Final Work Plan
Pre-Design Investigation
Operable Unit 2C, Landfill Sites 3 and 5
Former Marine Corps Air Station
El Toro, California

Subj: FINAL WORK PLAN AND HEALTH AND SAFETY PLAN, PRE-DESIGN
INVESTIGATION, OPERABLE UNIT 2C, LANDFILL SITES 3 AND 5, FORMER
MARINE CORPS AIR STATION (MCAS), EL TORO, CALIFORNIA

This work plan incorporates comments received on the *draft Work Plan* that was prepared by Foster Wheeler Environmental Corporation (FWEC) (FWEC 2000). A response to comments was prepared and submitted to the reviewers and is included in Appendix B.

| Date: 07-02 | Former MCAS El Toro | Figure 2-3 |

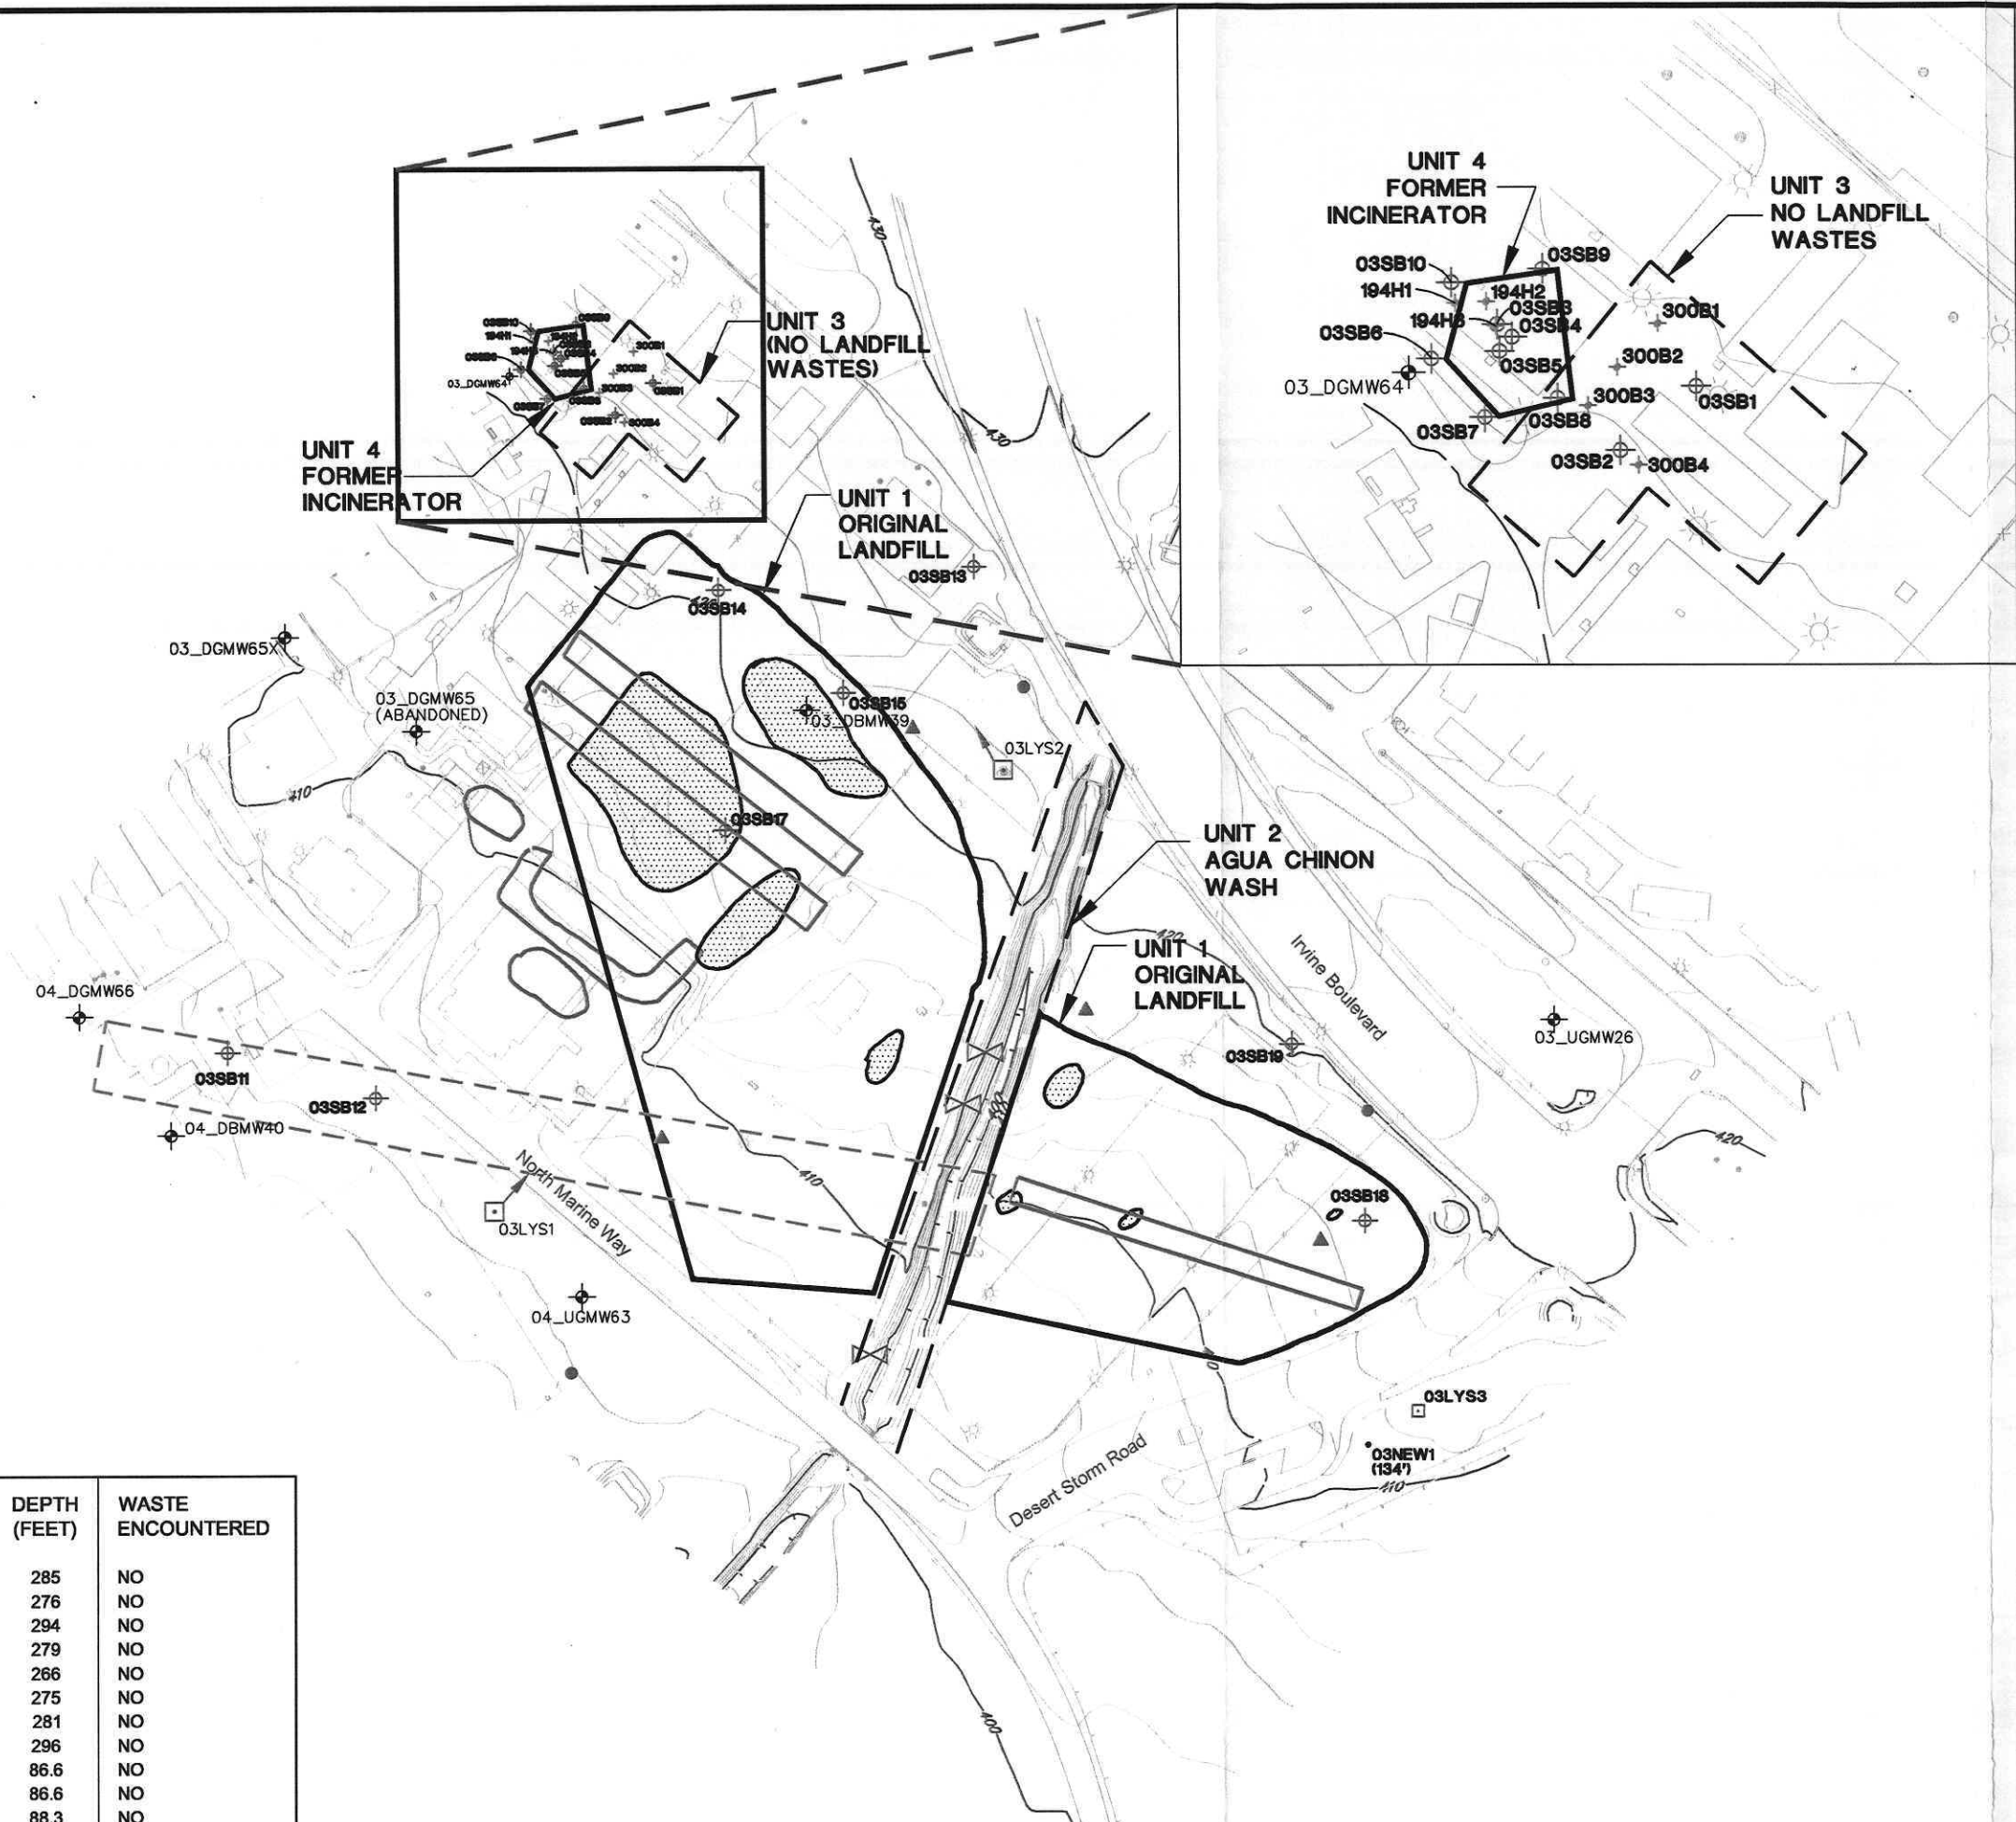
| Comment No. | Section/ Page No. | Comment | Response |
|--------------------------|----------------------|-----------------------------------------------------------------------------------------------------------------------------------------------------------------------------------------------------------------------------------------------------------------------------------------------------------------------------------------------------------------------------------------------------------------------------------------------------------------------------------------------------------------------------------------------------------------------------------------------------------------------------------------------------------------------------------------------------------------------|----------------------------------------------------------------------------------------------------------------------------------------------------------------------------------------------------------------------------------------------------------------------------------------------------------------------------------------------------------------------------------------------------------------------------------------------------------------------------------------------------------------------------------------------------------------------------------------------------------------------------------------------------------------------------------------------------------------------------------------------------------------------------------------------------------------------------------------------------------------------------------------------------------------------------------------------------------------------------------------------------------------------------------------------------------------|
| 5. | 3.1.1.1 | Section 3.1.1.1 describes anomalies determined by the geophysical investigations for Site 3. No anomalies are shown on Figure 4. Please revise Figure 4 to show all anomalies found. | Anomalies identified during the RI that may intersect the landfill boundary at Site 3 has been added to Figure 2-3 (of the Final Work Plan) and evaluated, where possible, to confirm the lateral and vertical extent of waste/fill material. |

| Comment No. | Section/ Page No. | Comment | Response |
|-------------|----------------------|-----------------------------------------------------------------------------------------------------------------------------------------------------------------------------------------------------------------------------------------------------------------------------------------------------------------------------------------------------------------------------------------------------------------------------------------------------------------------------------------------------------------------------------------------------------------------------------------------------------------------|-----------------------------------------------------------------------------------------------------------------------------------------------------------------------------------------------------------------------------------------------------------------------------------------------------------------------------------------------------------------------------------------------------------------------------------------------------------------|
| 27. | | On Figure 4, the trench locations proposed for Site 3 are shown. Absent are any evaluations of either the banks of Aqua Chinon Wash (both east and west banks) or the area around Building 796 (reported in Section 3.2 as the building for which waste was observed in the foundation excavation). Note that the Aqua Chinon Wash banks could be composed of edge Berms used for waste perimeter control, similar to situations found at many other solid waste landfills of the mid-1900s. Please revise the project approach and the figure to accommodate investigation of both banks and the building perimeter. | <p>Trenches have been proposed to be excavated at both banks of the Aqua Chinon Wash, and adjacent to Building 796.</p> <p>Trenches will be advanced in the vicinity of the building(s) where possible, with consideration for foundations, utilities, or other limiting factors. In addition, if the building(s) are within the limits of the landfill boundary these data will be taken into consideration during the preparation of the remedial design.</p> |

| Comment No. | Section/ Page No. | Comment | Response |
|-----------------------------------------------------------------------------------------------------------------------------------------------------------------------------------------------------------------------------------------------------------------------------------------------------------------------------------------|----------------------|---------------------------------------------------------------------------------------------------------------------------------------------------------------------------------------------------------------------------------------------------------------------------------------------------------------------------------------------------------------------------------------------------------------------------|--------------------------------------------------------------------------------------------------------------------------------------------------------------------------------------------------------------------------------------------------------------------------------------------------------------------------------------------------------------------------------------------------------------------------------------------------------|
| 2. | 3.1.1.3 | <p>Section 3.1.1.3 – Soil Borings: In the second paragraph, 03-DGMW65 and 04-DGMW66 are listed but their locations are not shown on Figure 4, Site Plan and Proposed Trench Locations. Also, 03-DGMW65 is not included in the notes that show "depth" and "waste encountered."</p> <p>Please show the locations of 03-DGMW65 and 04-DGMW66 on Figure 4 and include notes (depth and waste encountered) for 03-DGMW65.</p> | <p>Figure 4 in the Draft Project Work Plan is now presented as Figure 2-3 in the Final Work Plan</p> <p>The location of borings 03_DGMW65 and 03_DGMW66 are shown and identified. Well 03_DGMW65 was abandoned and identified as such on Figure 4. The Table on Figure 4 has also been revised to show the depth of the borehole 03_DGMW65, which was approximately 255 feet. No waste was encountered in this borehole.</p> |
| 3. | 3.1.1.3 | <p>Section 3.1.1.3 – Soil Borings: In the third paragraph, eighteen soil borings (03SB1 through 03SB15 and 03SB17 through 03SB19) are listed; however only borings 03SB11 through 03SB15 and 03SB17 through 03SB19 shown on Figure 4, Site Plan and Proposed Trench Locations.</p> <p>Please show the locations of borings 03SB1 through 03SB11 on Figure 4.</p> | <p>Borings 03SB01 through 03SB10 were drilled outside Unit 1 (landfill) and in and around Units 4 (former incinerator) and Unit 3 (solvent spill area). The 4th sentence, 4th paragraph of Section 2.2.1 has been revised to read: "Eight soil borings (03SB11 through 03SB15 and 03SB17 through 03SB19) and three lysimeter borings (03LYS1 through 03LYS3) were drilled during the Phase II RI in and around Site 3-Unit."</p> |

| Comment No. | Section/ Page No. | Comment | Response |
|-------------|-------------------|-------------------------------------------------------------------------------------------------------------------------------------------------------------------------------------------------------------------------------------------------------------------------------------------------------------------------------------------------------------------------------------------------------------------------------------------------------------------------------------------------------------------------------------------------------------------------|--------------------------------------------------------------------------------------------------------------------------------------------------------------------------------------------------------|
| 15. | Figure 4 | <p>Figure 4 – Site Plan and Proposed Trench Locations: The location of an abandoned monitoring well is shown approximate 100 feet west of Unit 1 of the Original Landfill.</p> <p>Please include the original designation for this monitoring well.</p> | <p>Figure 4 has been revised and the abandoned well is identified as 03_DGMW65.</p> <p>Figure 4 in the Draft Project Work Plan is now Figure 2-3 in the Final Work Plan.</p> |

| Comment No. | Section/ Page No. | Comment | Response |
|-----------------------------------------------------------------------------------------------------------------------------------------------------------------------------------------------------------------------------------------------------------------------------------------------------------------------------------------|-------------------|---------------------------------------------------------------------------------------------------------------------------------------------------------------------------------------------------------------------------------------------------------------------------------------------------------------------------------------------------------------------------------------------------------------------------------------------------------------------------------------------------------------------------------------------------------------------------------------------------------------------------------------------------------------|------------------------------------------------------------------------------------------------------------------------------------------------------------------------------------------------------------------------------------------------------------------------------------------------------------------------------------------------------------------------------------------------------------------------------------------------------------------------------------------------------------------------------------------------------------------------------------------------------------------------------------------------------------------------------------------------------------------------------------------------------|
| 2. | 3.0 | The draft work plan provides background information regarding previous waste limit delineation efforts performed by DON/USMC (see Section 3 of draft work plan). Based on this information, estimated landfill boundaries were plotted for Sites 3 and 5 on Figures 4 and 5 by DON/USMC. However, based on a review of Figure 4, it appears that some borings drilled within the estimated landfill boundaries (Borings 03SB14 and 03SB18) did not encounter refuse (see draft work plan at Page 3-3). Given this, could DON/USMC further explain the rationale used to plot the estimated landfill boundary shown in Figures 4 and 5 of the draft work plan? | <p>The landfill boundaries for Sites 3 and 5 that are shown on Figures 4 and 5, respectively, are the estimated limits of exposed and buried waste established in the Remedial Investigation (RI) Reports for Sites 3 and 5. The RI reports were prepared by Bechtel National, Inc. (BNI) and were reviewed and approved by all pertinent regulatory agencies; the rationale used to delineate the landfill boundaries was also presented.</p> <p>Borings 03SB14 and 03SB18 did not encounter refuse, but the trenching activity proposed in the Final Work Plan will confirm landfill boundaries shown in the RI Report.</p> <p>Figures 4 and 5 in the Draft Project Work Plan are now presented as Figures 2-3 and 2-4 in the Final Work Plan.</p> |
